Safety Notice N°3

## LOCKING MECHANISM ISSUES WITH THE QUICK RELEASE BUCKLES LIGHT

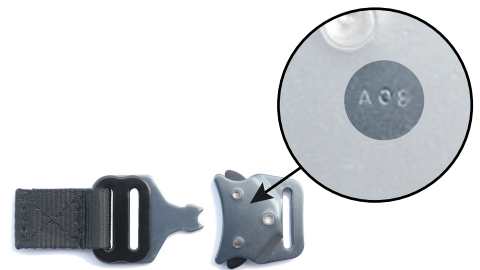
*A few harnesses equipped with light quick release buckles have experienced involuntary releases of the locking mechanism in flight and primarily with the front (red) Safe-T buckle.*

*The two small protruding release mechanism on the female side of the buckle, do not come back in place to secure a fully locked position.*

The possibly malfunctioning buckles are stamped with the following markings : A08 or B08 which corresponds to their manufacturing date ( date also indicated on the harness's label ), valid between January 2008 and July 2008. The defect is located on the female part of the buckle.

*Note: if your harness was upgraded with the light quick release buckles, make certain to verify the stamping on the buckles and find out if they are part of the above potentially problematic series*
